BURLINGTON DEVELOPMENT REVIEW BOARD

Tuesday October 15th, 2019, 5:00 PM

PUBLIC HEARING NOTICE

TO: Development Review Board
FROM: Scott Gustin
DATE: October 15, 2019
RE: 20-0317CU; 702 Lake Street

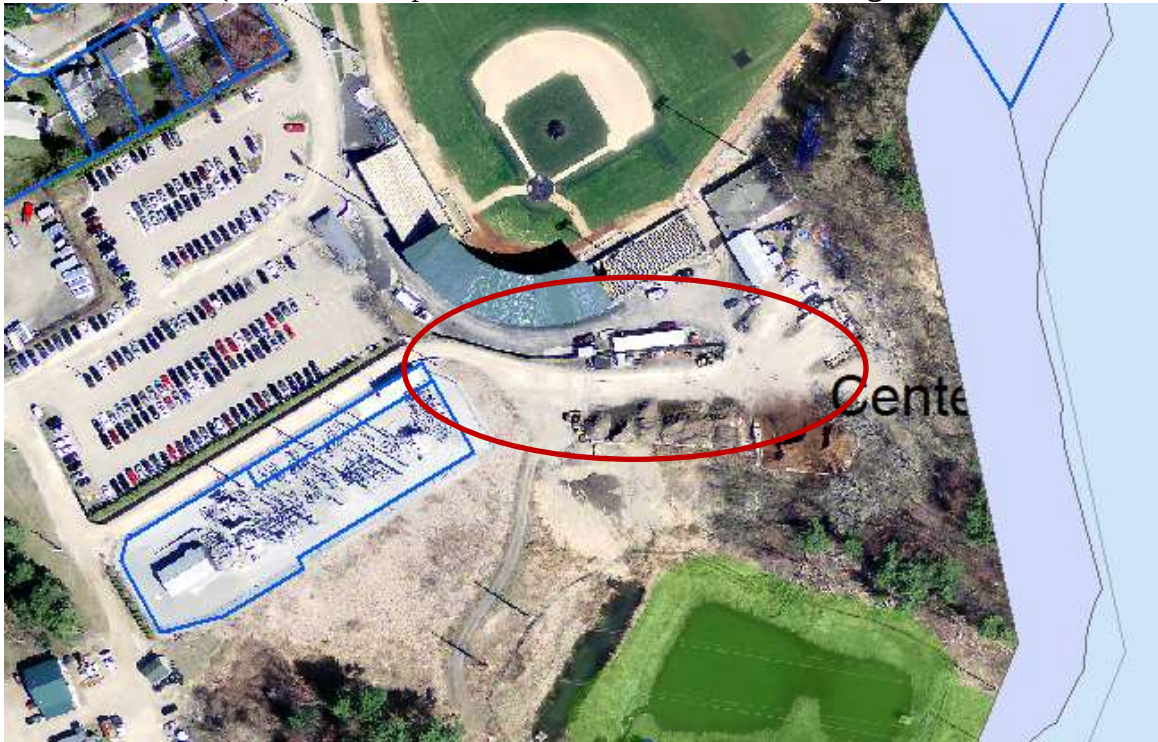
The development area is outside the mapped Riparian and Littoral Conservation Zone (green) and the NR wetland area (blue). See map detail, below. **Affirmative finding.**

Drawing No.
SP-1

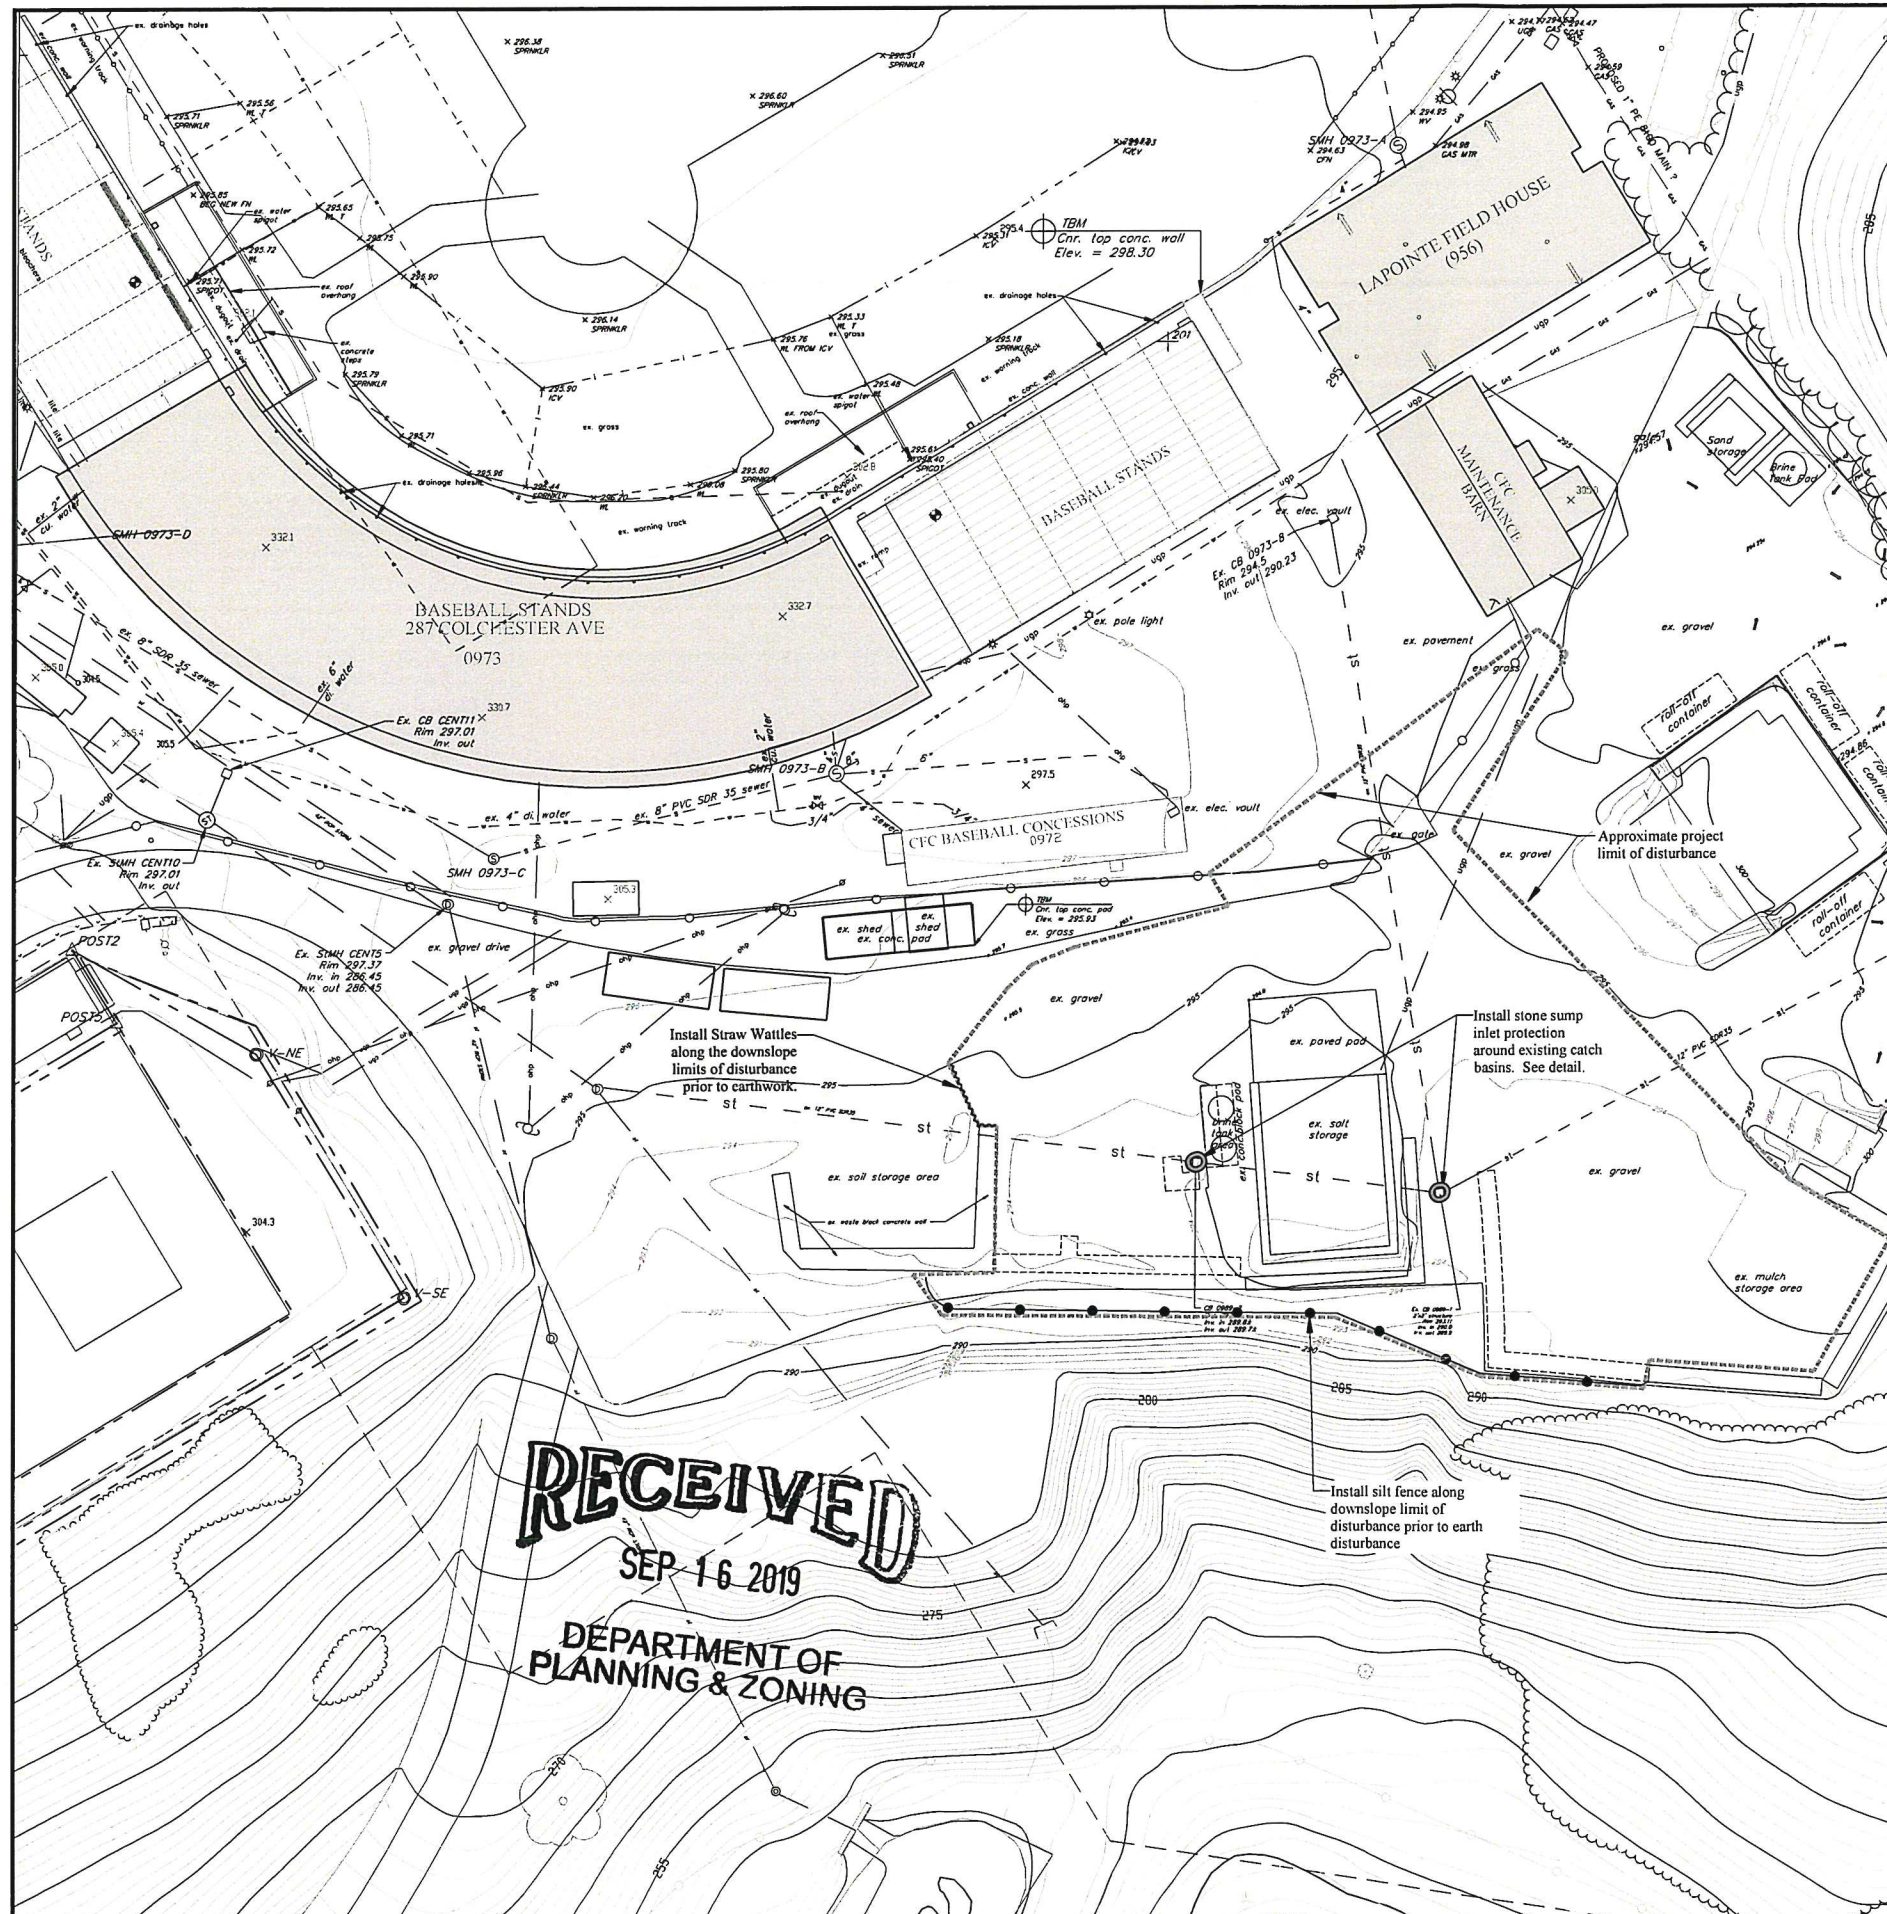
An existing fence will be relocated to improve vehicular circulation. A new electric gate with controller will be installed at the southwesterly entrance to the access road. See Inset A, Site Plan SP-1. Chain link fencing and gate are consistent with the use and location of this proposal. **Affirmative finding.**

SITE ELECTRICAL PLAN
SCALE: 1" = 30'

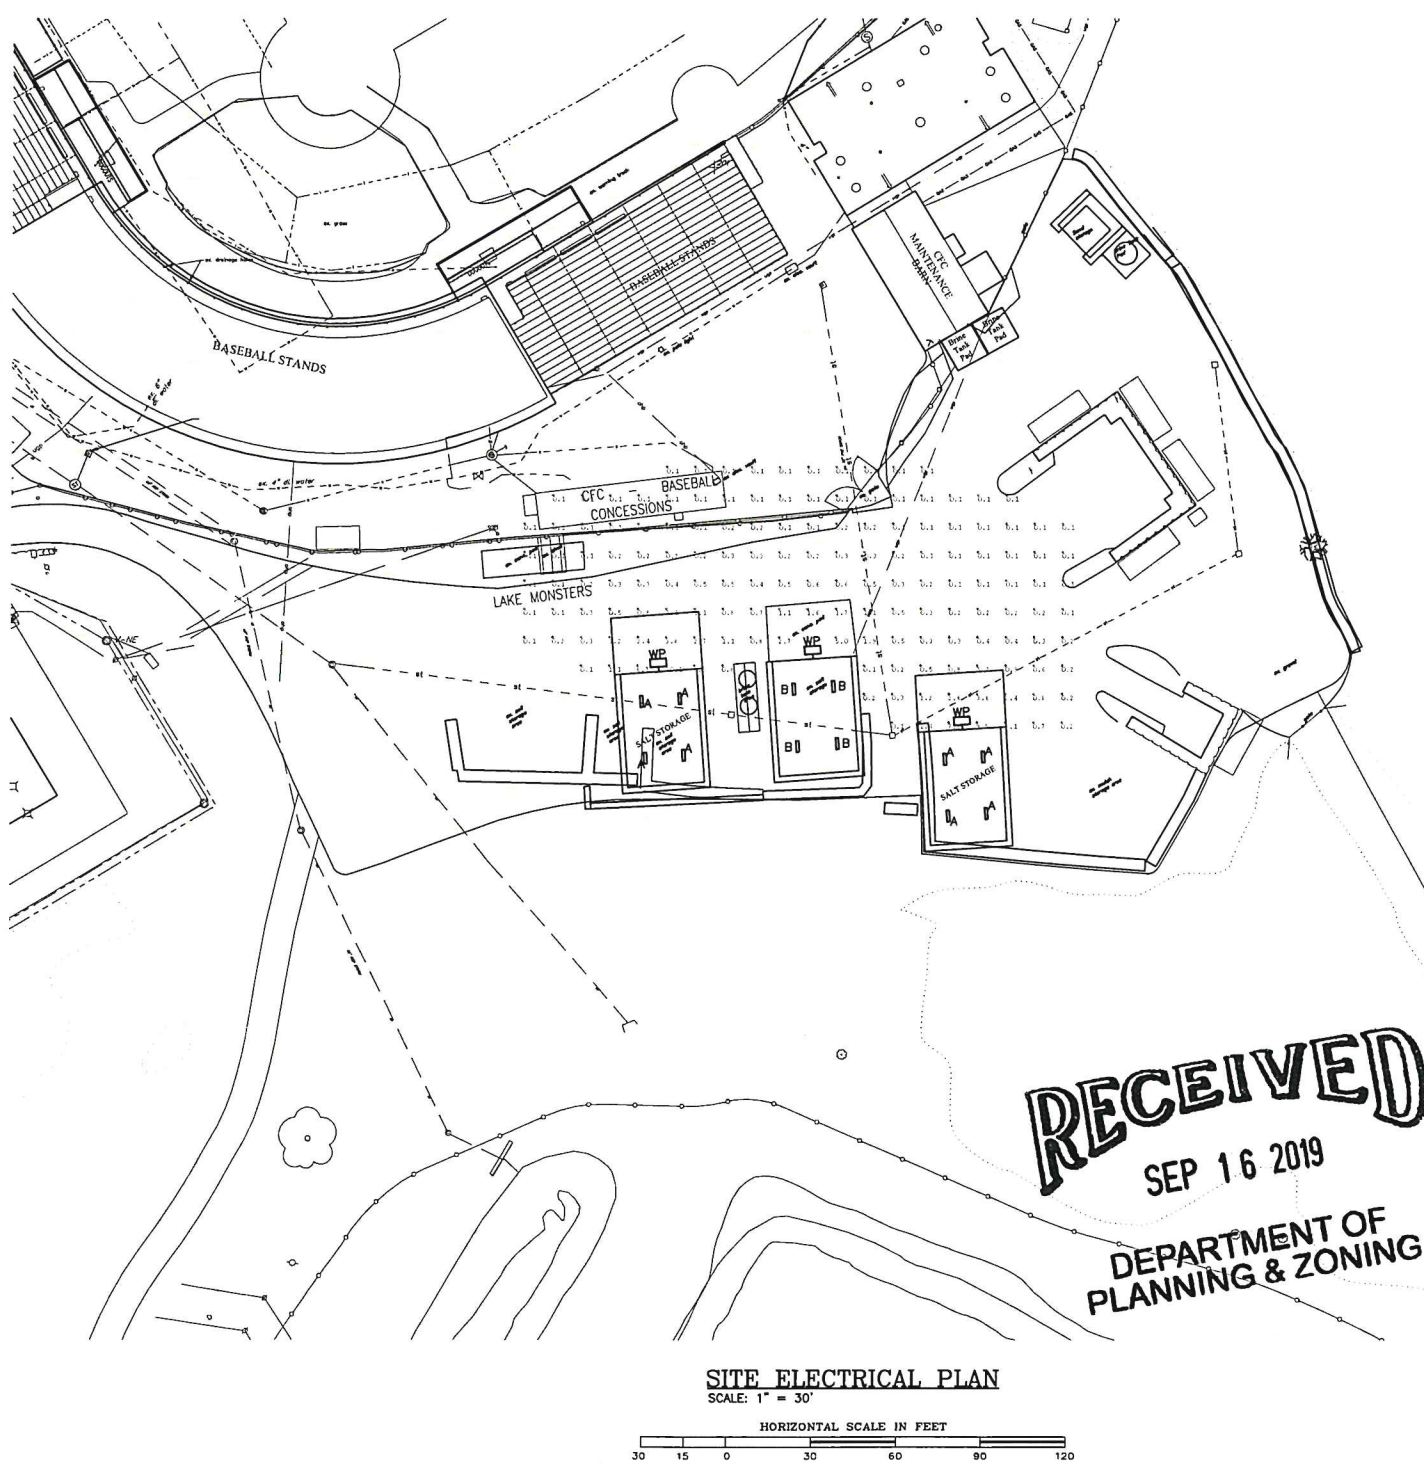
LED lighting is proposed both within (vapor tight) and at the entrance (wall packs) of the new salt sheds. Average light levels are low. Refer to Plan PM-1. **Affirmative finding.**

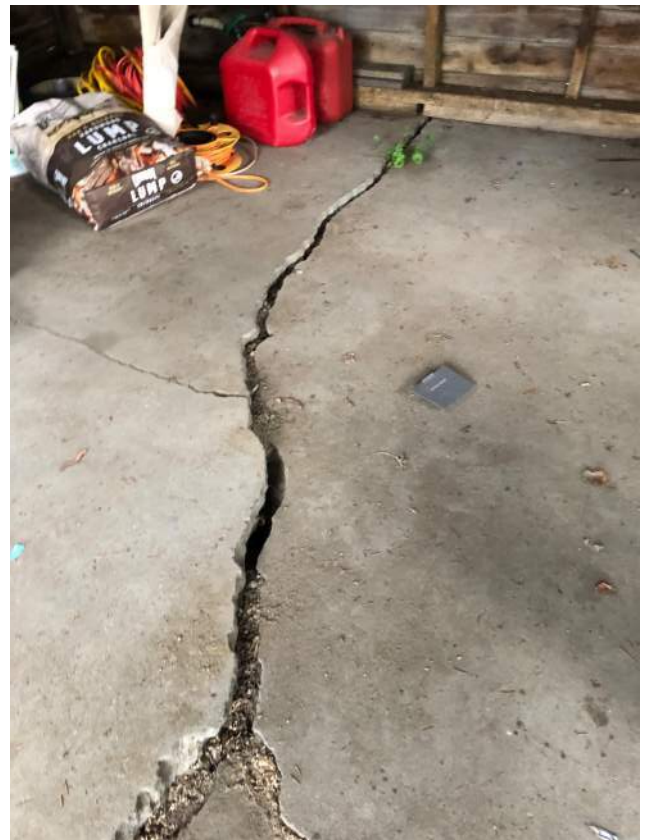
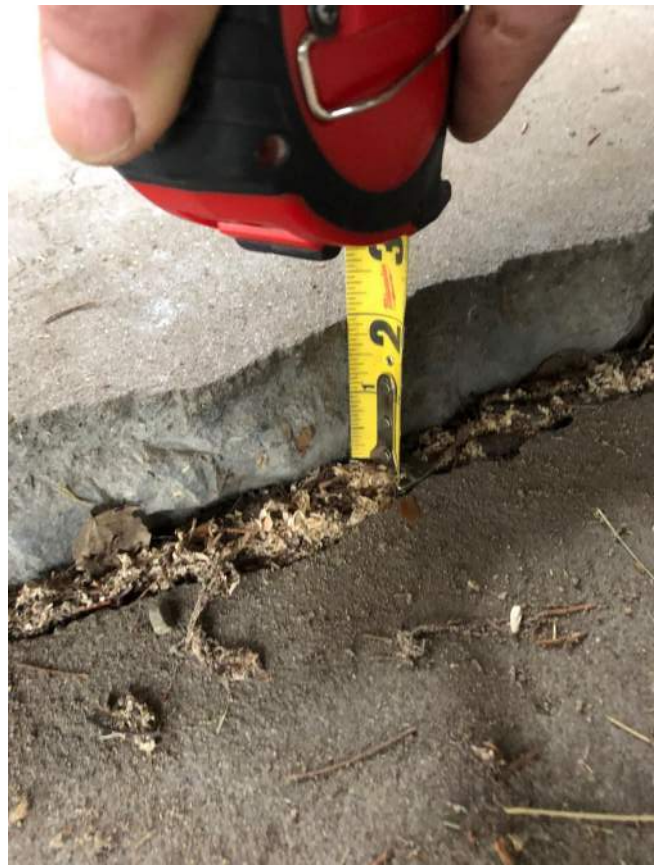
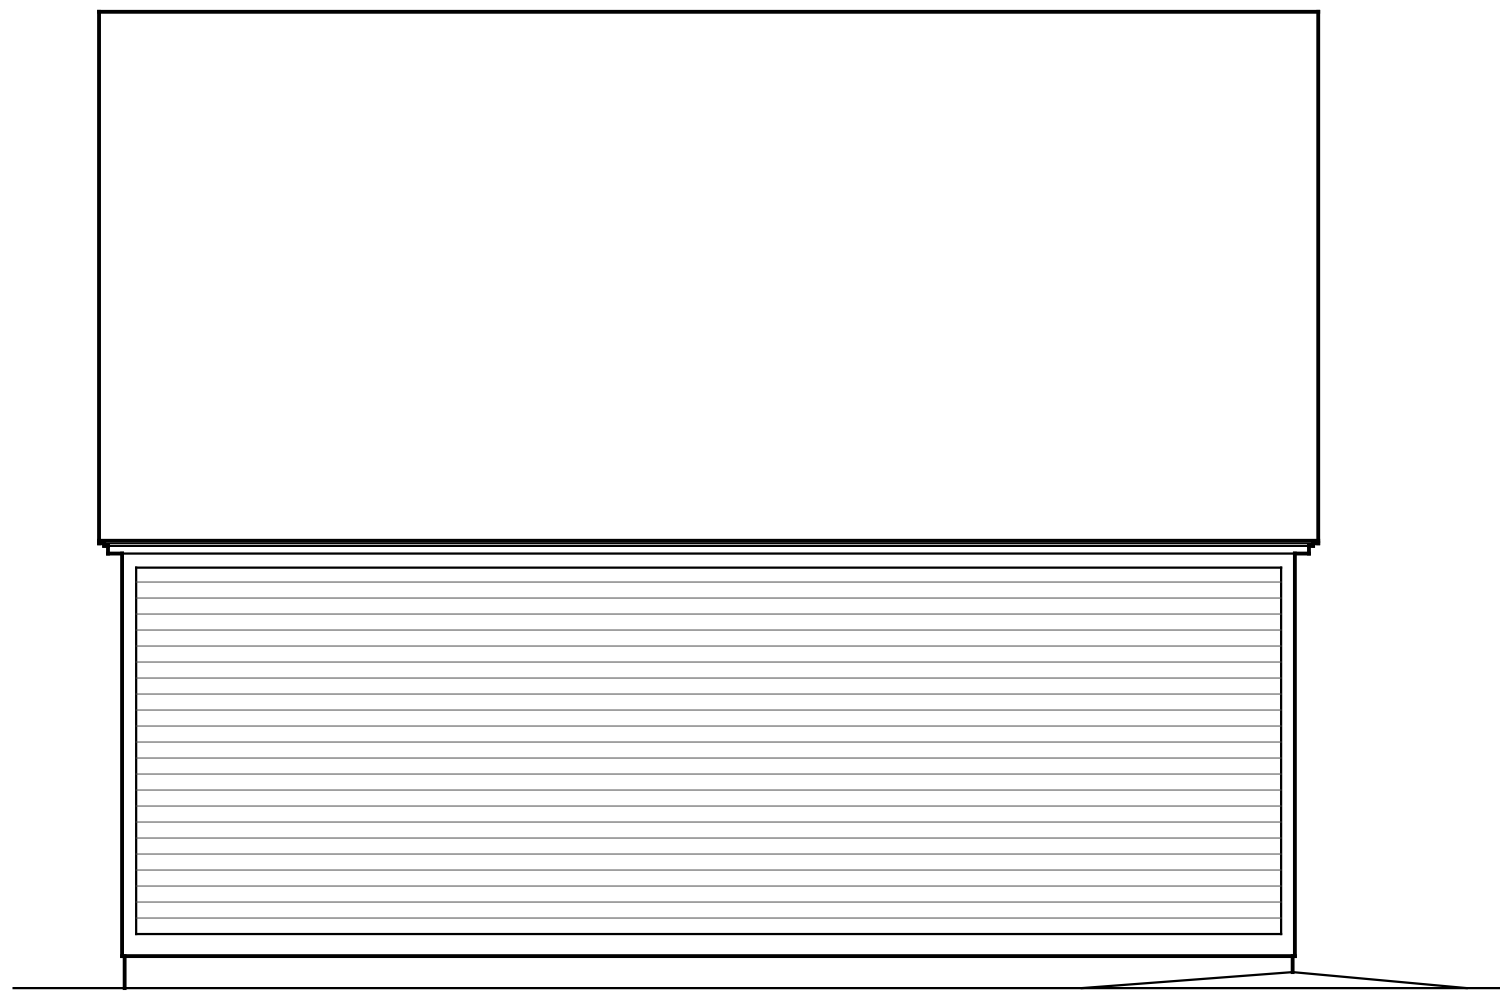
The poor state of the foundation has allowed moisture to migrate up the walls - these were constructed without sheathing or other lateral support elements such as let-in bracing - the horizontal wood siding is applied directly to the studs. Moisture intrusion directly through the siding is evident also. Moisture, rot and fungus activity is evident at the sill plates, lower portions of studs and at the backside of the siding around window and door openings. The siding is failing at much of the lower portions of the walls.

The roof sheathing and a significant number of rafters are rotted and there is fungus activity visible throughout. There are also a number of holes in the roofing and sheathing.

Base upon our observations and our professional experience, we do not think this garage structure is suitable for rehabilitation. The structure is not an exemplary instance of its type, and it exhibits below average craftsmanship. Any attempted rehab of this existing structure would require reconstruction to such a degree that little of the original building would remain intact. The added complexity and cost of such a rehab is an undue burden. In this case we believe that removing the structure completely and reconstructing as a new garage from the foundation up with a substantially similar design is a reasonable alternative approach.
